UNITED STATES PATENT AND TRADEMARK OFFICE

APPLICATION NO.	FILING DATE	FIRST NAMED INVENTOR	ATTORNEY DOCKET NO.	CONFIRMATION NO.
10/092,560	03/08/2002	Ernesto E. Blanco	217395US25CIP	2081
22850 7590 10/09/2009 OBLON, SPIVAK, MCCLELLAND MAIER & NEUSTADT, L.L.P. 1940 DUKE STREET ALEXANDRIA, VA 22314				
EXAMINER				
MOULTON, ELIZABETH ROSE				
ART UNIT		PAPER NUMBER		
3767				
NOTIFICATION DATE		DELIVERY MODE		
10/09/2009		ELECTRONIC

Office Action Summary

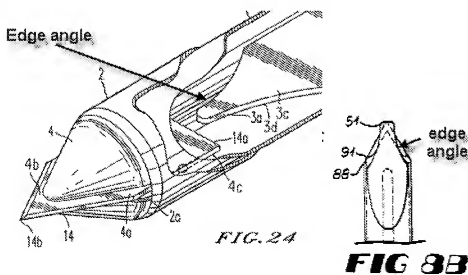
Danks '440 shows a trocar cutting blade (81) and a shield (15), which has a smaller edge angle than the cutting blade in plan view (Fig 7A-9B). The guard has upper (distal end of the blade) and lower (proximal end of the blade) surfaces are "substantially planar" see "there is a slight concavity 94 as the distal end 51 of the shield 15 proceeds from the blunt end 92 to a shoulder 93."

It would have been obvious to one of ordinary skill in the art at the time the invention was made to use the shield and blade shapes of Danks '440 with the trocar of Danks '773 in order to provide a trocar wherein "it is possible for the blunt end 92 to cover the pointed distal end 87 of the blade 81 so that no additional penetration is possible, while still leaving portions of the sharpened edges 91 exposed. In this fashion, when the pointed distal end 87 of the blade 81 has penetrated the body cavity wall, but before the blade 81 is entirely through the wall, the blunt end 92 of the shield can move forward and be partially locked while still allowing the sharpened edges 91 of the pointed blade 81 to expand the incision in the body cavity wall so that the obturator and cannula may be introduced to communicate with the body cavity."

Furthermore, the applicant has not disclosed that a planar GUARD serves any specific purpose or solves a stated problem. The specification repeatedly refers to a planar

BLADE creating a straight incision in the body, but never identifies the guard as performing this function.

3. Applicant's arguments are not persuasive. The guard is "substantially" planar along both sides. The examiner considers the disclosed "slight concavity" to be *substantially* planar. By simple comparison of applicant's figures and Dank's figures, one can see that the shape of the edge angles are identical:
